# Access Compliance Report

## Public Rights-of-Way

### (Curb Ramps)

| Intersection ID: 19725 | Main Street: COLONY_RD | Cross Street: GOVERNOR_MORRISON_ST | Location: E            |

| ADA ID: 58A27D5BE52E   | Ramp Type: PerpDiag    | Initial Pass/Fail: Fail            | Overall Compliance: No |

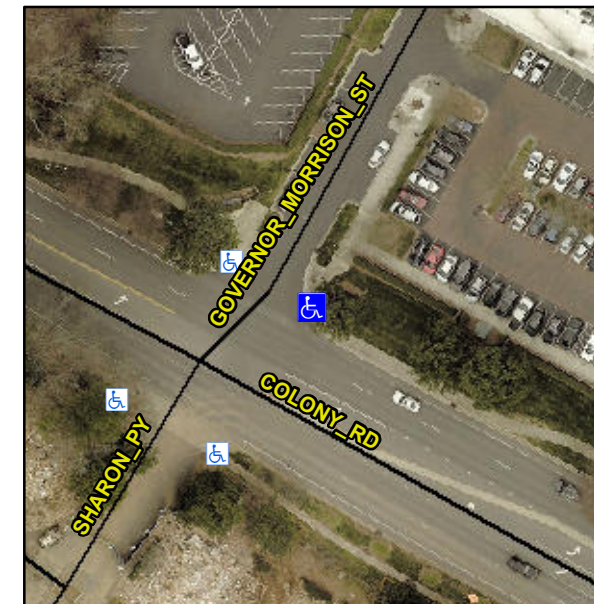
**Not Found, R304.2.2**

| Compliance | Description           | Data  | Compliance | Description                 | Data  |
|------------|-----------------------|-------|------------|-----------------------------|-------|
| N/A        | Ramp Length (in)      | 71.0  | No         | Ramp Slope (%)              | 8.6   |

**Remove & Replace Curb Ramp With Two New Directional Ramps or Equivalent.**
